# 1957 - 1962 Corvette: Chevrolet Advance Information: New Clutch Pressure Plate Released for 1962 Corvette

**Subject:** New Clutch Pressure Plate Released for 1962 Corvette

**Bulletin No:** A.I. #62-3

**Date:** November 28, 1961

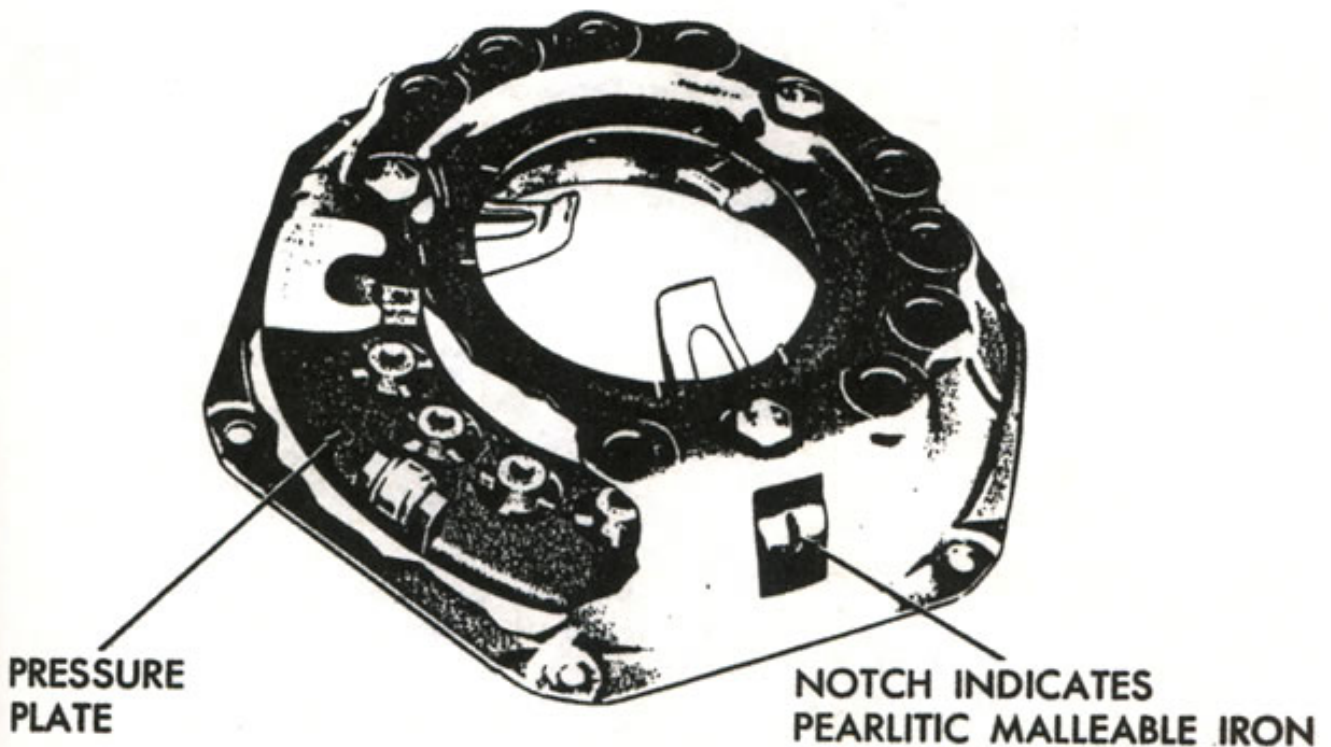
Due to the increased frequency of clutch failures on 1961 High-Performance Corvettes, Engineering has released a new clutch pressure plate made of pearlitic malleable iron in place of the previously used grey cast iron. This new material will provide improved resistance to failure at high RPM's for all mechanical tappet equipped 1962 Corvettes.

The pearlitic malleable iron pressure plate may be identified by a cast depression in each driving lug as shown in Figure 1.

The new pressure plate and the clutch cover-pressure plate assembly are interchangeable with past models from 1957-61. They will be used for service replacement on all 1961 High Performance (RPO 354 and 468) Corvettes as soon as parts are available, and will eventually service all 1957-61 models when present stock of 1961 material is exhausted.
